## Appendix B Proposed Changes to Schedule 1 Process Descriptions

### Schedule 1 Proposed Changes

**Schedule 7: Site Plan Changes**

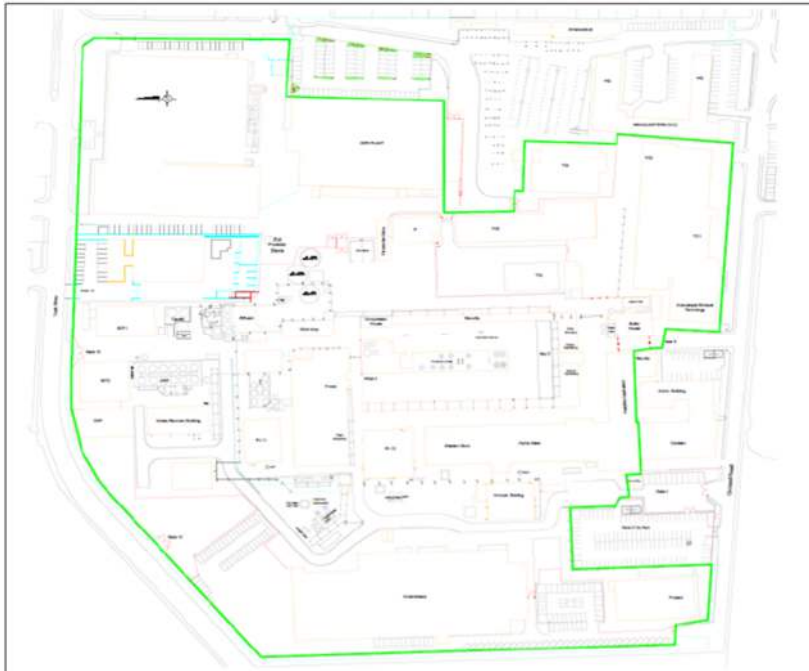
**Existing Permit Boundary**

**Requested Permit Boundary**
